Certificate of Appropriateness

Property 1927-A N. 2ND ST. Brewers Hill Historic District

Date issued 6/20/2017 PTS ID 114219 COA:reside rear house and stain wood

Current conditions.

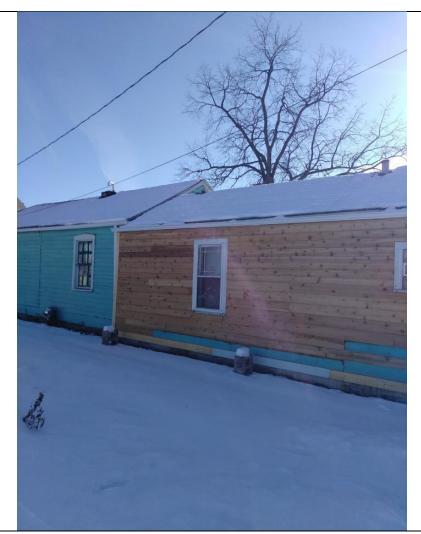
Knotty wood must be removed and replaced with clear, smooth, and knot-free lap siding.
